TECHNICAL UPDATE

Number June '82

Distributed as a free service to all Lazair owners

5.2 TINY BUBBLES IN THE LINE

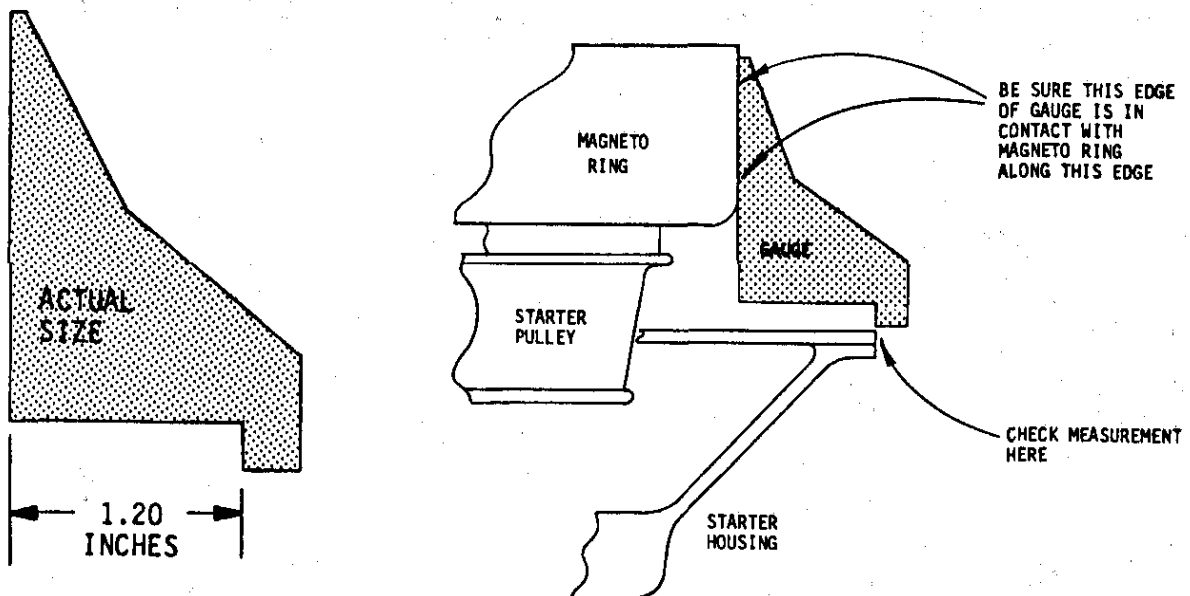
After one of our factory demonstrators displayed some noticeable bubbles, we checked the fuel line for leaks and determined that there was no place where air could get into the line — this is the main advantage of the submersible fuel filter. Since the bubbles appear to emanate from within the fuel itself, it has been determined that the bubbles are not air, but vaporized fuel. The exact cause of these bubbles is difficult to determine, but it is believed that water in the fuel effectively plugs the filter. Then each time the diaphragm in the fuel pump is pulsed there is a momentary reduction in pressure in the fuel line. This reduction in pressure lasts for only a very small fraction of a second, but it is sufficient to cause a small amount of fuel to vaporize and form a tiny (almost invisible) bubble. These gradually merge to form larger bubbles as they migrate toward the carburetor.

This theory has not been proven, but it has gained credibility from the fact that any time the problem has occurred, it has been eliminated (completely) by removing the felt from the fuel filter and rolling and stretching it to get rid of the water.

We are now investigating the use of other materials (such as a brass screen) to eliminate the felt filter. In the meantime, check your fuel lines for bubbles frequently while flying. Check your filter periodically (especially if you suspect there may be water in the fuel). Roll the felt between your hands, stretch it, compress it and then put it back on.

5.4 PROPELLER BOLTS

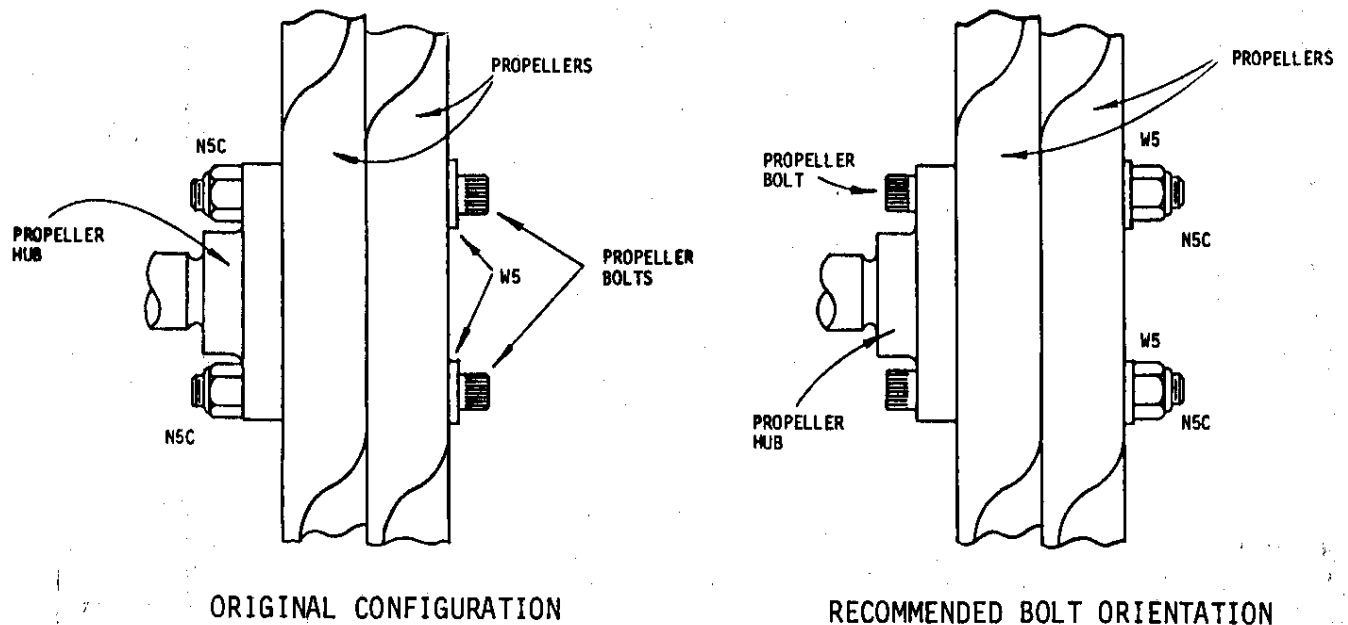
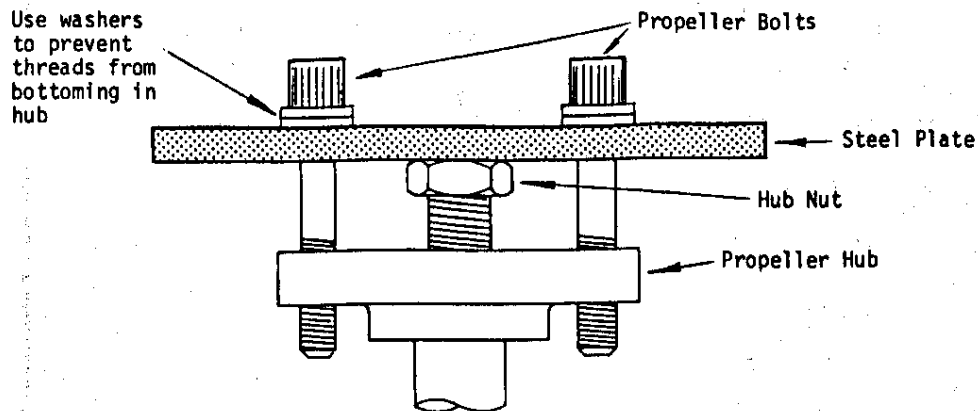
To reduce the possibility of a bolt failure (even if a propeller is improperly installed) all kits shipped after May 17, 1982 have the bolts inserted through the hub in the opposite direction to that in the original configuration. To increase the margin of safety, it is recommended that owners of Lazairs shipped prior to May 17, 1982 reverse their propeller bolts as shown below.

This requires drilling out the holes in the propeller hub to 5/16 inches diameter, and allows the part of the bolt which goes through the hub (where the stress is highest) to be the full diameter. As originally configured, the bolts were threaded into the propeller hub.

The threads on the bolt not only reduce the cross sectional area of the bolt by approximately forty percent, but they also introduce a stress concentration, which, under fatigue loads, can be as high as 2.7 to 1. By reversing the bolts, the threaded part of the bolt is moved from the area of maximum stress to the area of minimum stress.

When drilling the holes to 5/16" diameter, make sure the drill is perpendicular to the face of the hub. Make sure you put the bolts in the hub before you install the hub on the crankshaft.

To reinstall the propeller hub, make sure the taper on the crankshaft and the hole in the hub are absolutely clean and free of grease. Apply a small amount of Loctite 242 or similar locking compound, fit the hub onto the shaft and tighten the nut to a torque of 35 foot pounds. After the propellers are installed, the NSC propeller nuts should be tightened to a torque of 15 foot pounds.

5.10.1 BALANCE (CENTRE-OF-GRAVITY) CHECK

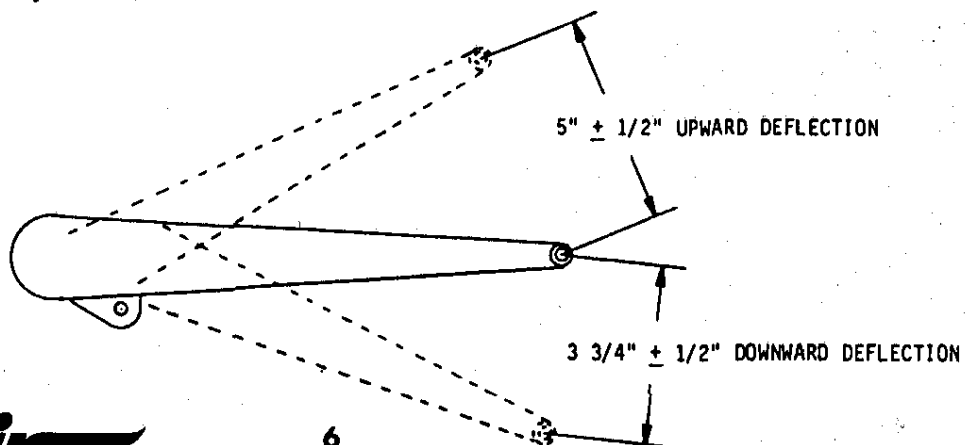
With the aircraft on the ground and the pilot sitting in the seat in the normal (or most comfortable) seating position, raise the tail until the boom is level (use a spirit level). Hold the aircraft in this position with a bathroom scale under the spreader (T11S). The reading on the scale should be between 1 and 5 pounds. If the aircraft meets this requirement it is adequately balanced for the first test flight (if possible the first flight should be made by an experienced Lazair pilot who is capable of recognizing any unusual flight characteristics). Fine tuning of the balance is best done by flying the aircraft and adjusting the centre-of-gravity for hands-off trim at the power setting and airspeed preferred by the pilot.

5.10.3 RUDDERVATOR DEFLECTION CHECK

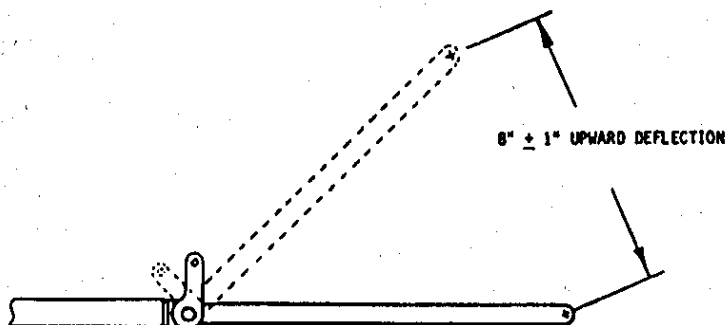
Push the stick forward as far as possible. The downward deflection of the ruddervators should be such that they almost touch each other. Adjust the length of pushrod T18 as required to achieve the correct downward deflection.

Pull the stick back as far as possible. The upward deflection of the ruddervator (from the neutral position) should be within the limits shown. Adjust the stop on the control stick as required to obtain the correct upward ruddervator deflection. If the stop is moved, be sure to recheck the downward travel and readjust if necessary.
